NEWSLETTER

JULY 13TH 2016

SOFTWARE VERSION 2.3 - NEW FEATURES

INSTALLATION GUIDE R1C - NEW FEATURES

REDUCED TIGHTENING TORQUE

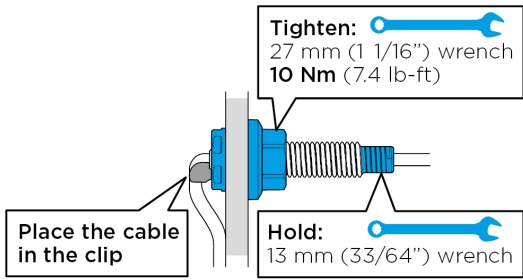
Thru-hull nut tightening torque reduced to 10Nm (1 kg on 1 m lever).

INTERCEPTOR CHECK

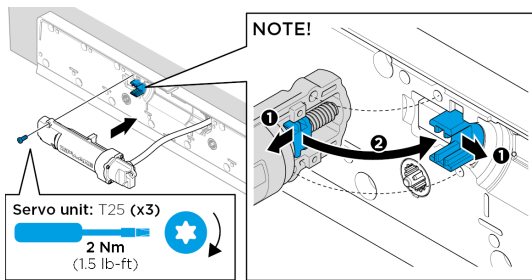
The Initial start procedure now highlights the important Interceptor Check and an extra note emphasizing that "All readings must be green".

It is recommended that a first check is always made right after installing the interceptors, before launching the boat. If an Interceptor then shows excessive servo motor torque, the prime suspect is the flatness of the transom behind the interceptor and/or excess antifouling between its blades.

NOTE! Corrective actions are always necessary in the event that too high torque levels are observed. **All readings must be green!**

SYMBOL CLARIFYING TRANSOM SIDE

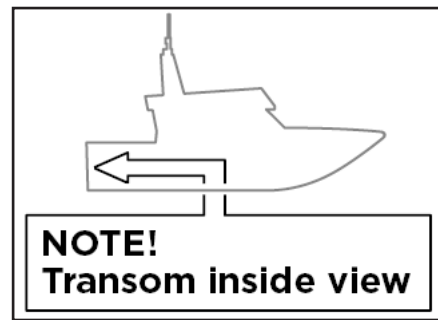
The wiring diagram now shows with a symbol the depicted side of the transom.

CONTROL PANEL - ANGLE RANGE

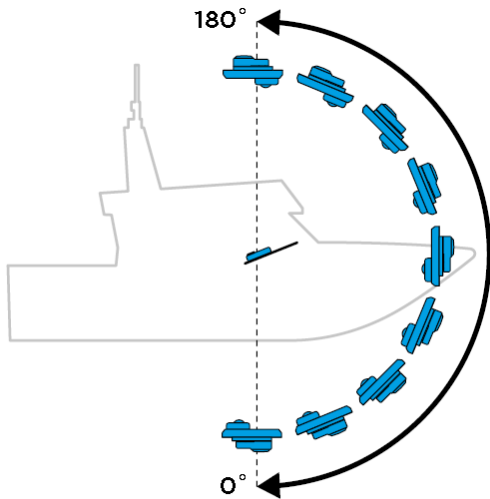
Control panel installation angle range increased and made less ambiguous.

NOTE! Any angle between 0-180°
